ATTACHMENT 1 – SECTION 106 CORRESPONDENCE RECORD

U.S. Department
of Transportation

Re: Initiation of Section 106 Consultation, Washington Union Station Expansion Project

Figure 1. Parking and Retail Revenues for Fiscal Years 2000 Through 2012, in thousands of dollars

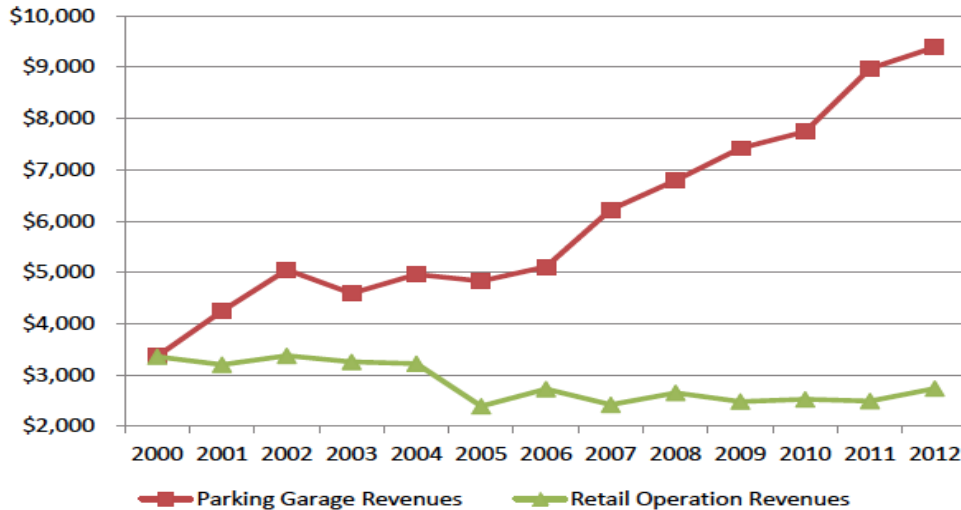
2000 and 2012, parking revenues increased from \$3.4 million to \$9.4 million, while commercial operations revenues decreased from \$3.4 million to \$2.7 million (see Figure 1).

Alternative A-C Distributed PUDO

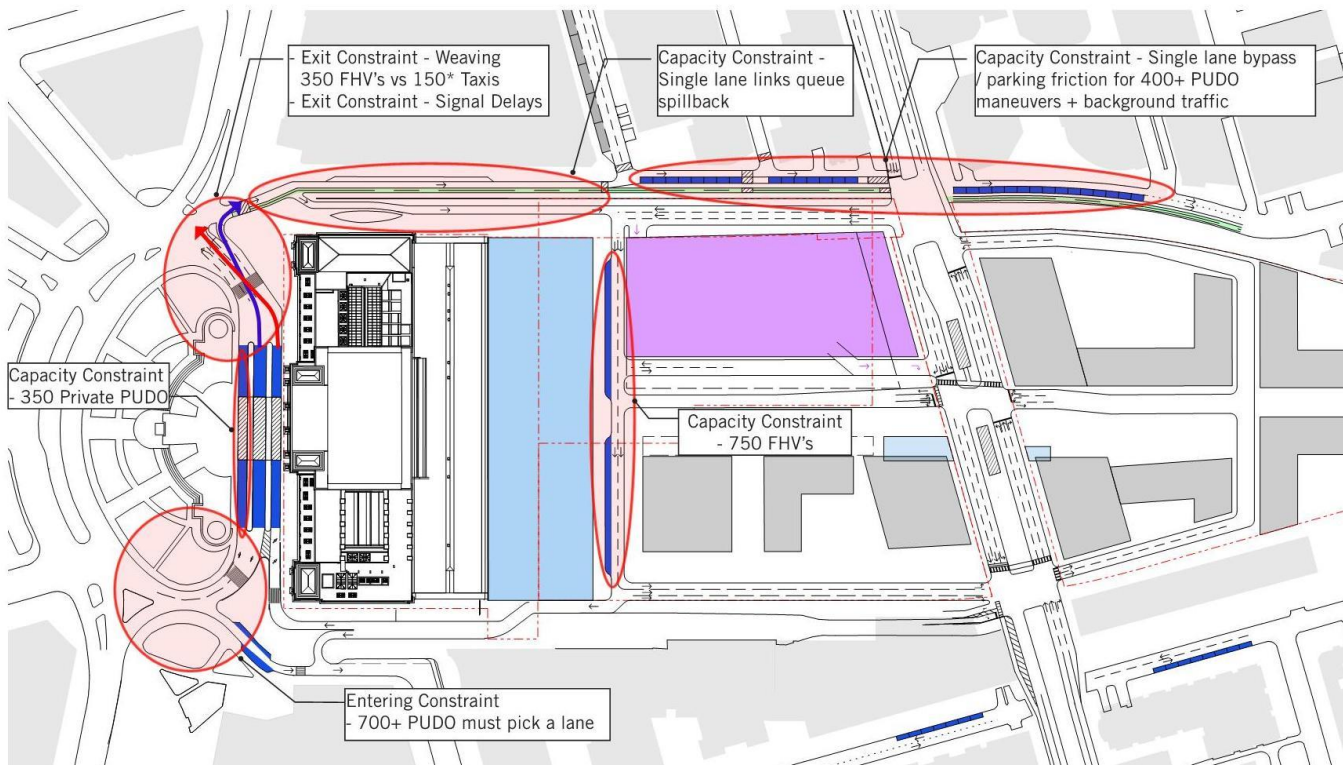
station. And PUDO circulation at the east and west ramps proposed in Alternative A-C will further harm pedestrian and bicycle uses and appreciation of the historic station setting and building.

ALTERNATIVE A-C ABOVE-GRADE PLAN

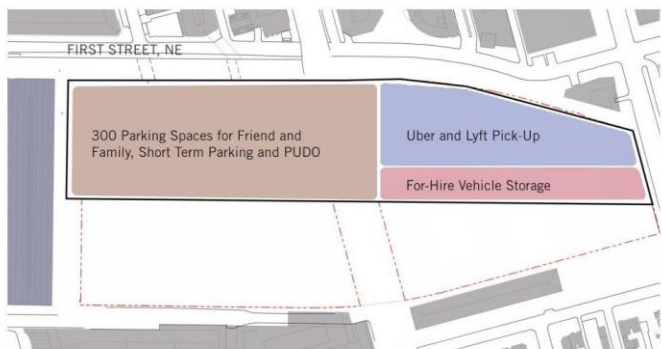
The option of locating a high-capacity PUDO facility above the bus facility is worthy of study given it is the only other location in which a dedicated PUDO area could be considered. However, there are several drawbacks to this location, some of which cannot be overcome or mitigated. Principal among these drawbacks is the fact that the needed program cannot be accommodated on a single level of an above-grade garage, instead requiring multiple levels to achieve the same functionality of the A-C Modified below-grade facility. Providing the full program on multiple levels leads to significant and possibly fatal operational difficulties. The proposed Alternative A-C garage includes a footprint for each parking level of approximately 115,000 square feet. This compares to 480,000 square feet available on one level below-grade. Even if right-sized station parking were included within the above-grade garage, fulfilling the PUDO functions described above would take at least three additional garage levels. This bus, parking and PUDO garage would create nearly the same adverse impacts as described in the *Parking* section above.

Image submitted on August 22, 2017 in the document titled “Analysis of Preliminary Alternative Impacts on BP”

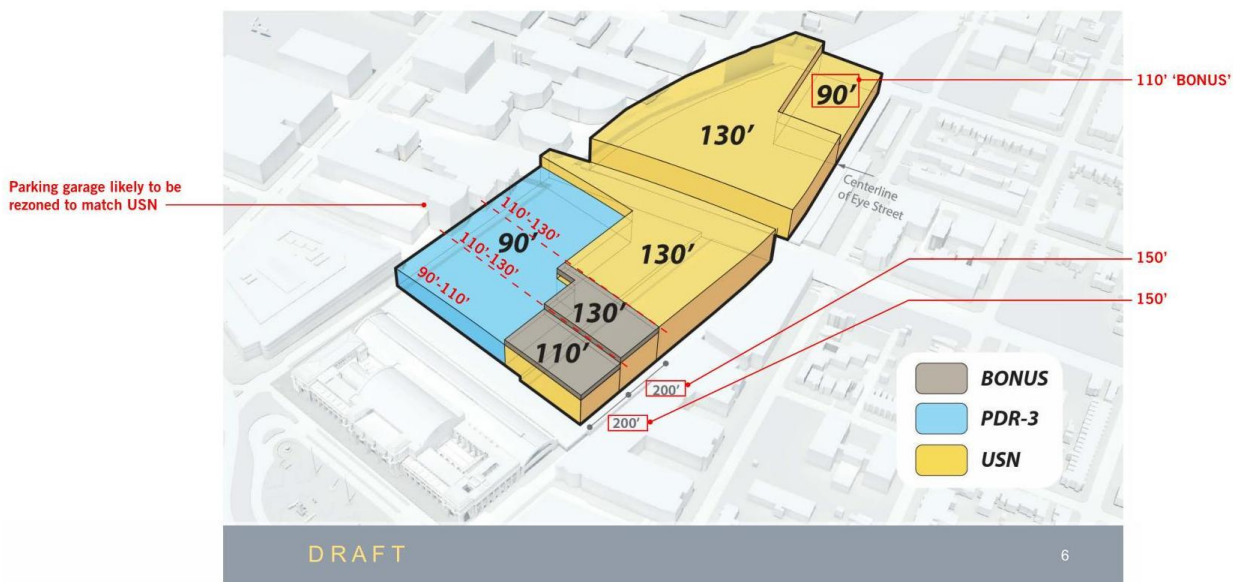
Appendix A5b, Section A-2.6 of the DEIS includes a zoning envelope diagram that contains inaccuracies regarding zoning permitted heights and setbacks from the south end of the Union Station North (USN) zone boundary line. The DEIS diagram describes a graduated height increase from that south boundary line as you move north along the centerline of the historic station in 200’ plan increments. The USN zoning regulations (DCMR Title 11, Subtitle K, Section 305.1) specifies a 150’ increment. The north-east corner of the USN zone district is similar to the far south bonus. USN zoning allows a 90’ building height, with a height bonus to 110’ permitted through design review and approval from the DC Zoning Commission.
